**Environment  
Agency Written  
Representation on  
Sizewell C  
Development  
Consent Order**

Our Reference: AE/2021/126206/01

2 June 2021

Fig 1. Diurnal Pattern of Fish Catch at Sizewell A Power Station. Averaged over 41 sampling days. Lightly stippled areas show range of times of dusk and dawn from mid-winter to mid-summer. Dark stippling shows hours of darkness common to all dates. (Turnpenny 1988)

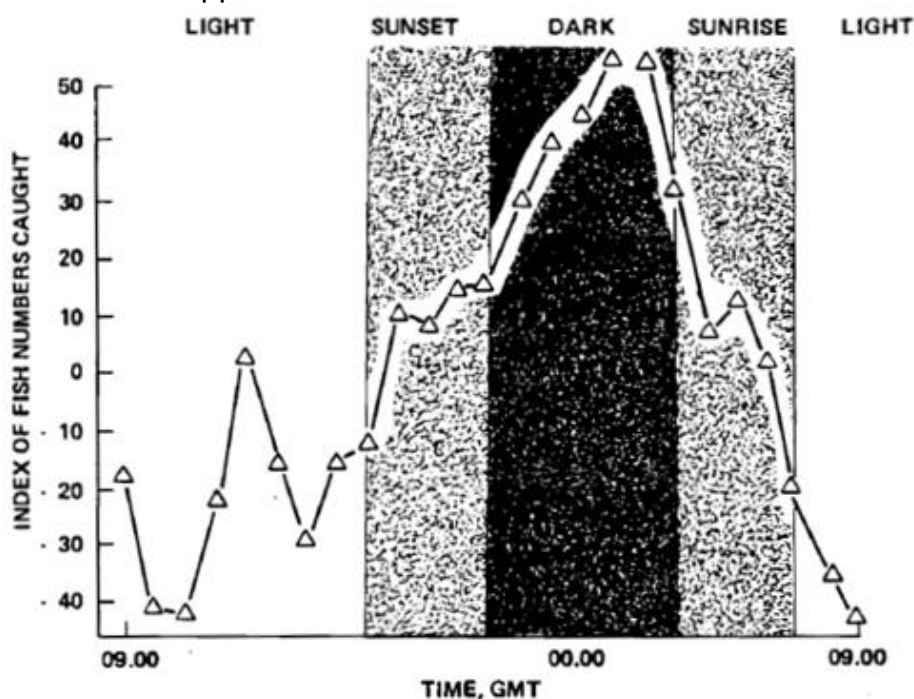
- 8.14 It is unclear if this finding can be applied to occasions when the bulk sample overflowed. Valid bulk samples are therefore potentially biased toward periods when catches were low and does not provide a valid test for the period when catches were high and more likely to overflow the net. Therefore there is uncertainty in what the true overnight impingement rate was on occasions when the bulk sample overflowed. And therefore there is doubt as to whether extrapolation of daytime hourly impingement rates to cover the bulk overnight period is a valid approach.

- 8.15 The diurnal patterns of screen catch has been recorded locally in separate surveys. Fig 1 shows the averaged hourly index of catch measured on 41 dates at Sizewell A Power Station and indicates that peak catches occurred at night; the figure is taken from 'The Behavioural Basis of Fish Exclusion from Coastal Power Station Cooling Water Intakes', Turnpenny (1988).
